Access Compliance Report

Public Rights-of-Way

(Curb Ramps)

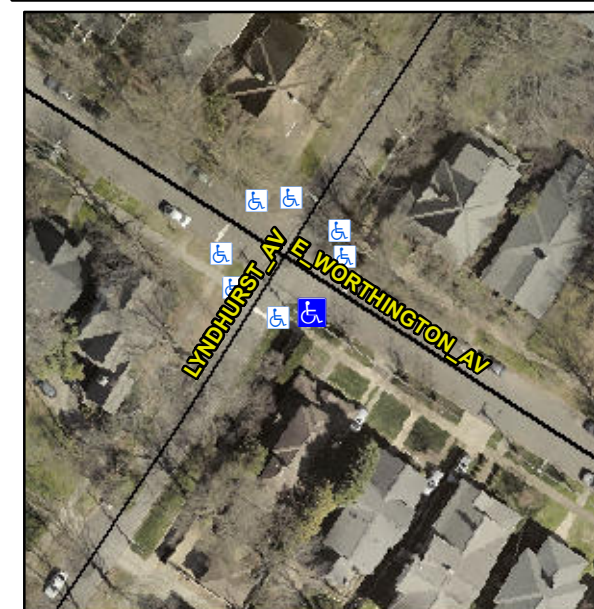
Not Found, R304.5.1, R304.5.3

Compliance	Description	Data	Compliance	Description	Data
N/A	Ramp Length (in)	55.0	Yes	Ramp Slope (%)	5.3
No	Ramp Width (in)	30.0	No	Ramp XSlope (%)	2.1
N/A	Flare Type LT	N/A	N/A	Flare Type RT	N/A
N/A	Flare Slope LT (%)	N/A	N/A	Flare Slope RT (%)	N/A
N/A	Flare Traversable LT?	N/A	N/A	Flare Traversable RT?	N/A
N/A	Landing Length (in)	N/A	N/A	DWS Provided?	N/A
N/A	Landing Width (in)	N/A	N/A	DWS Contrast?	N/A
N/A	Landing Slope (%)	N/A	N/A	DWS Length (in)	N/A
N/A	Landing X Slope (%)	N/A	N/A	DWS Full Width?	N/A
N/A	Landing Curb? (Y/N)	N/A	N/A	DWS Offset (in)	N/A
N/A	Shared Landing?	N/A			
N/A	Gutter Ponding?	N/A	N/A	Gutter Slope (%)	N/A
N/A	Gutter Lip Ht (in)	N/A	N/A	Gutter X Slope (%)	N/A
N/A	Painted X Walk1?	No	N/A	Painted X Walk2?	N/A
	X Walk 1 Direction	To NE		X Walk 2 Direction	N/A
N/A	X Walk 1 Width (in)	N/A	N/A	X Walk 2 Width (in)	N/A
	X Walk 1 Slope (%)	3.3		X Walk 2 Slope (%)	N/A
	X Walk 1 X Slope (%)	1.0		X Walk 2 X Slope (%)	N/A

Remove & Replace Entire Ramp.
